# **AJAX Soils Review**

## **Kent Watson**

### **April 10, 2016**

This document reviews the following Appendices in the Ajax Environmental Impact Study. I have focused on the soils, geology and landform portions of the report. I have used screen captures for maps, tables and text sections that are too large to re-type. The documents were copy protected and text could not be copied and pasted.

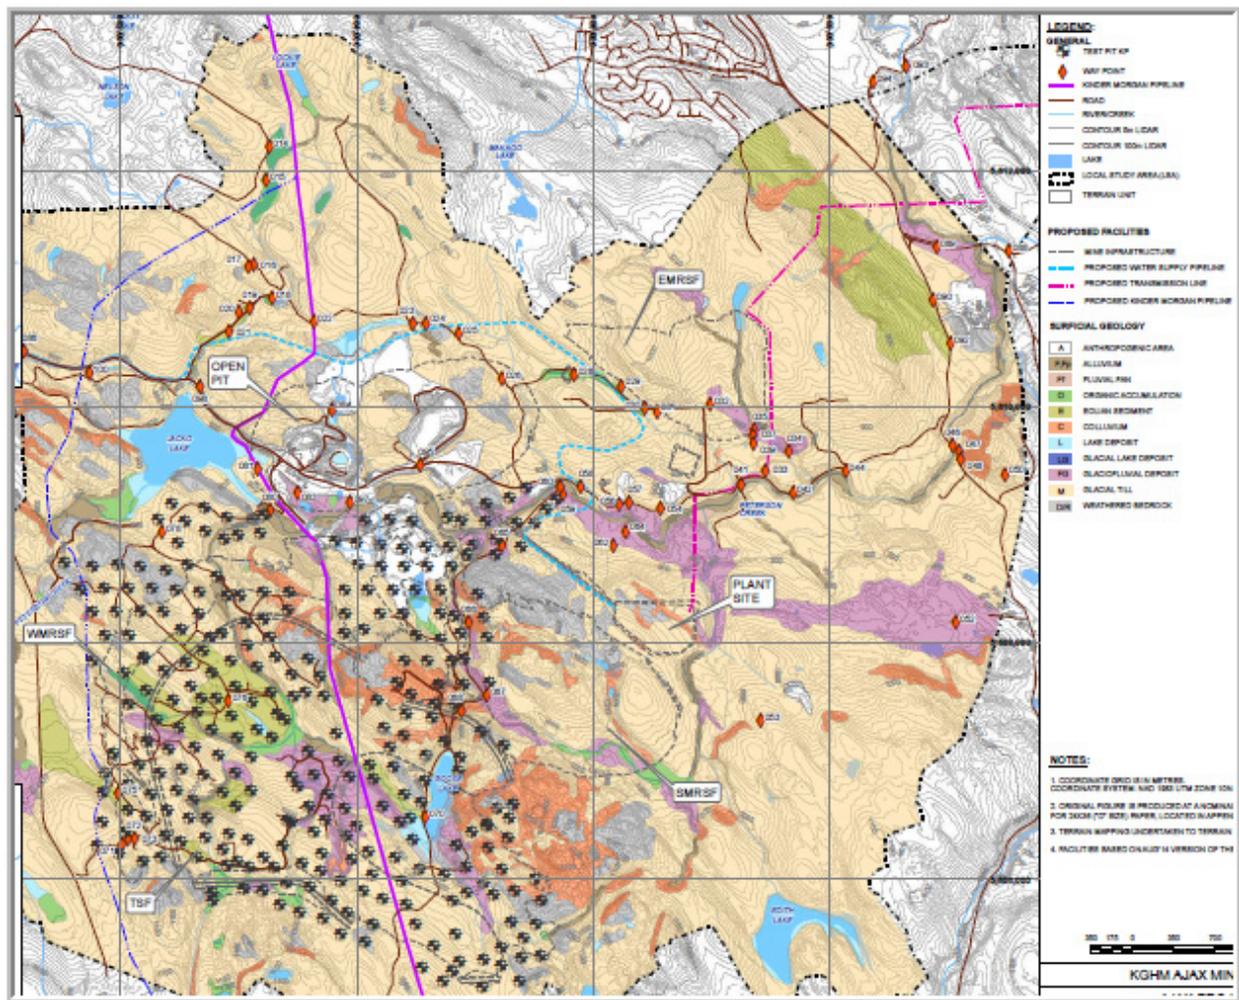
**Figure 27** The way points for the information shown in **Figure 26** are red diamonds. 75 scratch pits were done. They were not classified to the Canadian System of Soil Classification (1998) texture class names

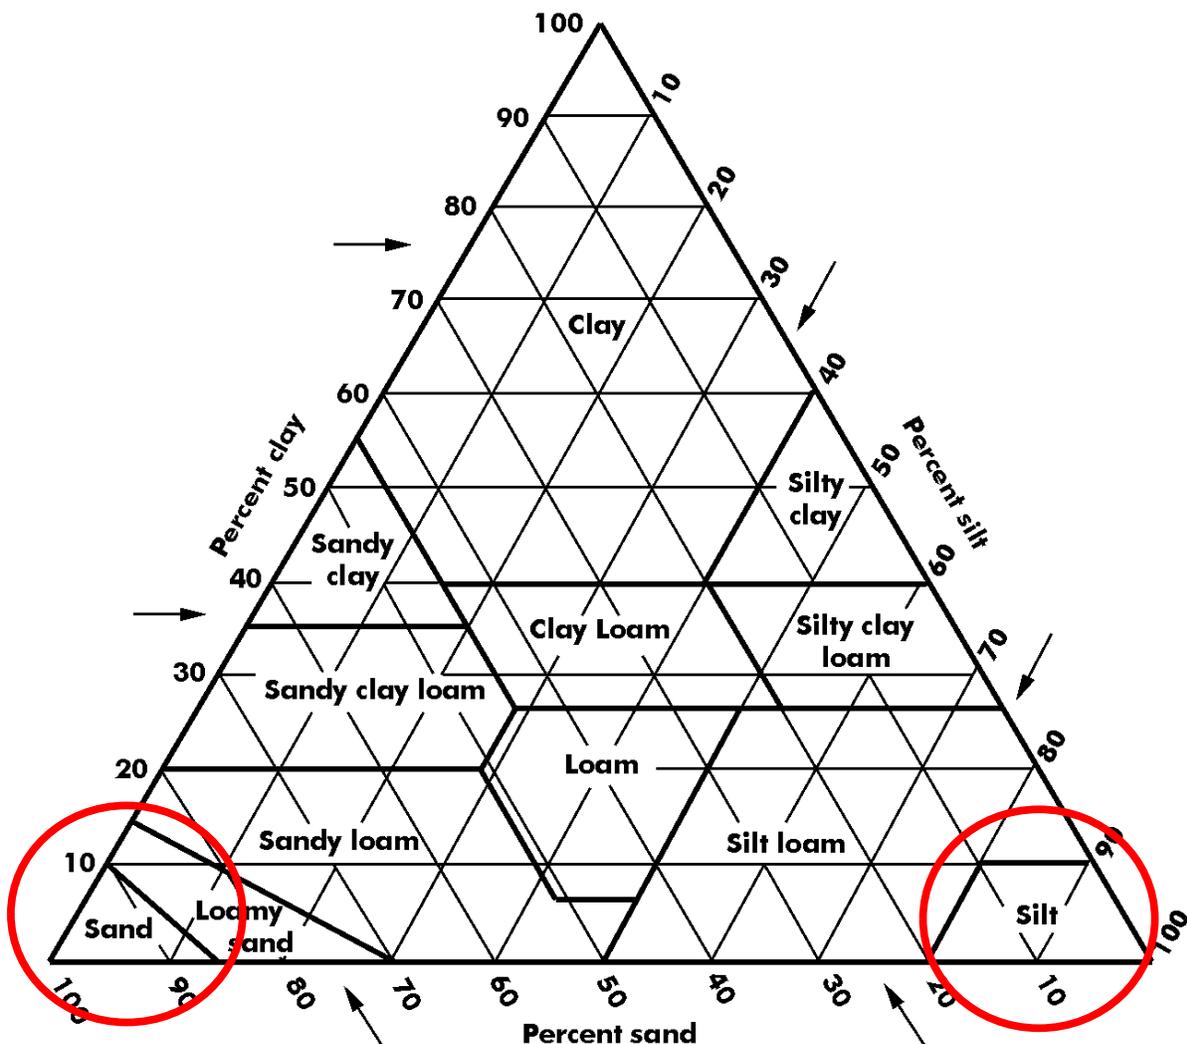
**Figure 30** The soil textures reported in Appendix 6.2.A and from 383 test pits and over burden bore holes in Appendix 6.6.A were reported as follows: Silt, Silty Sand, Clay Sand, Silty Gravelly Sand, Gravelly Sandy Silt, Trace Clay, Sandy Silt, Silty Sand Gravel, Sand and Silt, Sandy Gravel and any combination of these words. These are not correct texture terms. They do not follow CSSC classification texture class names. There are no percentages given so there was no idea how much silt there would be in the topsoil and overburden. Nor was the percent silt in the topsoil and overburden ever given. Was this to hide the amount of silt present in these materials. Using the texture percentages from Appendix I was able to calculate the percent silt in the overburden and top soil and the volume as we have seen is immense. From the 75 scratch pit sites the 383 test pits (**Figure 30**) and bore hole tests (**Figure 31**) (I never counted how many there were) every texture was either a sand or a silt (red circles) and this is an impossibility. It is absurd and clearly demonstrates that no one involved in these studies has any concept of what soil texture is or how to determine it. It just looks like guess work to me,

Figure 34 Cross section of EMRSF showing glacial lacustrine under glacial till. Cross sections locations are found on page 763 of Appendix 3 - I – Geotechnical Report - Mine Site infrastructure.

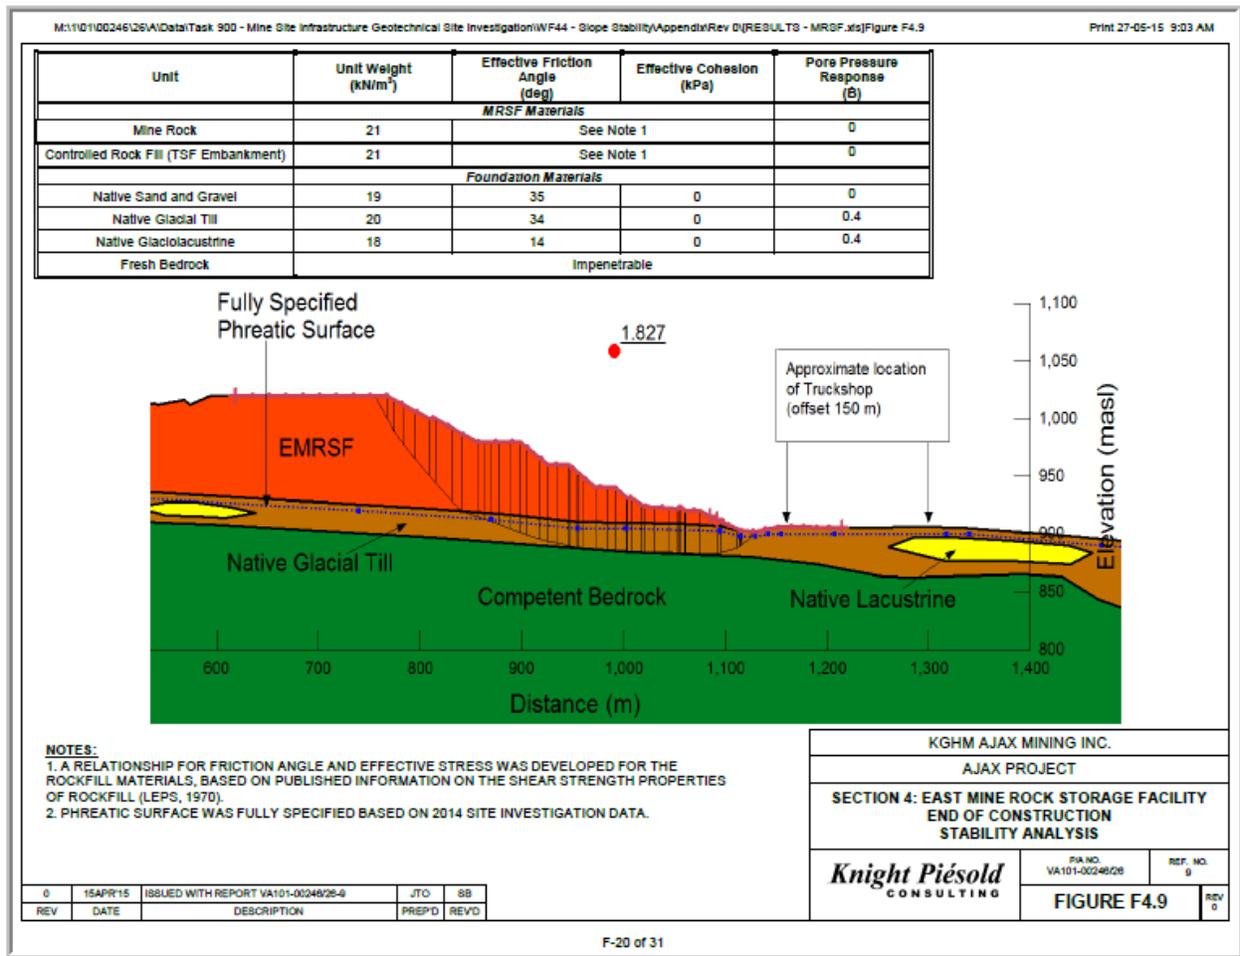
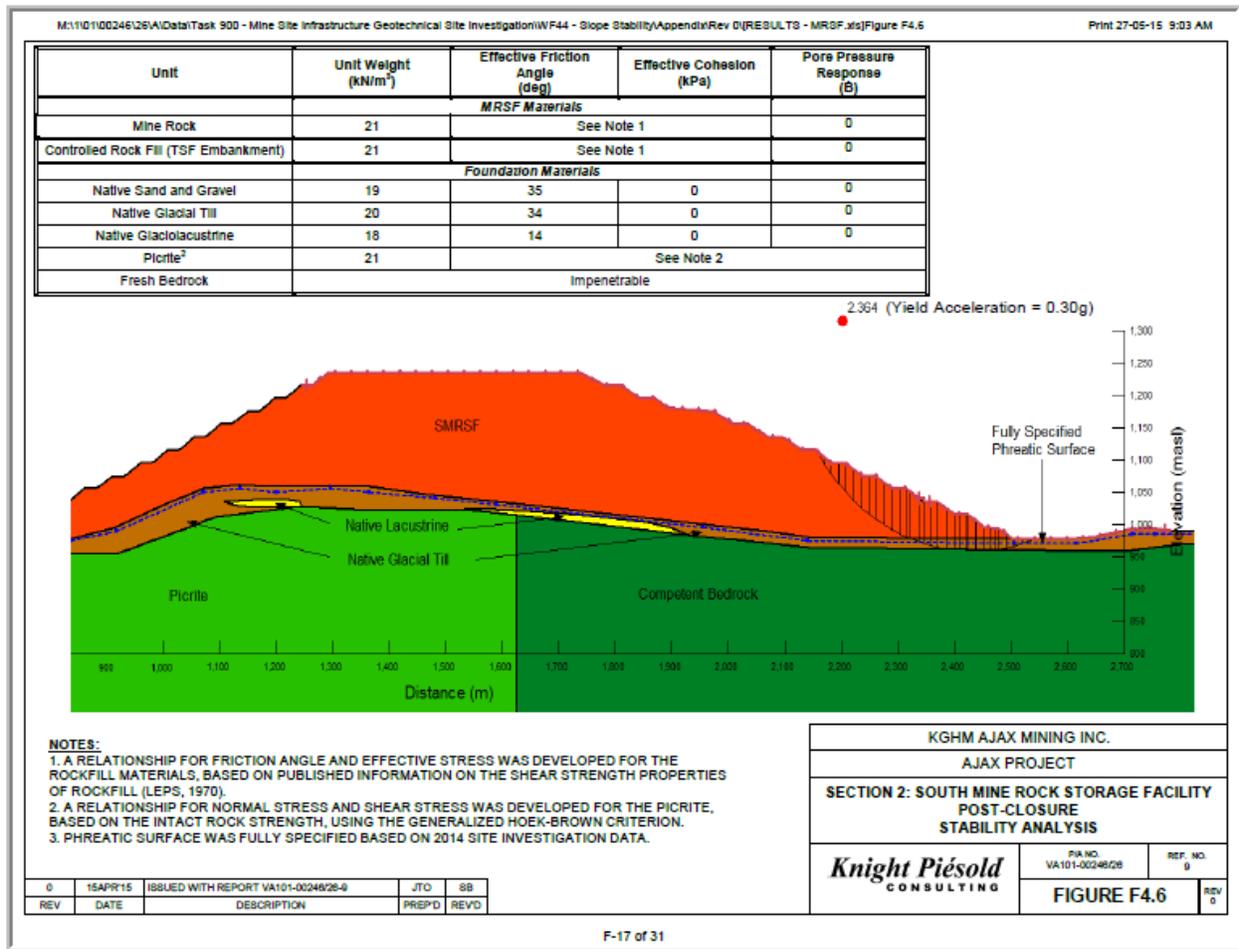
**Figure 32** The Mt Poly tailings failure resulted from the failure of the Upper Glacial Lacustrine unit. These same units exist under glacial tills in the EMRSF and SMRSF rock dumps as shown in the following figures. This is a concern because ground water may shift and saturate these sediments which could lead to failure.
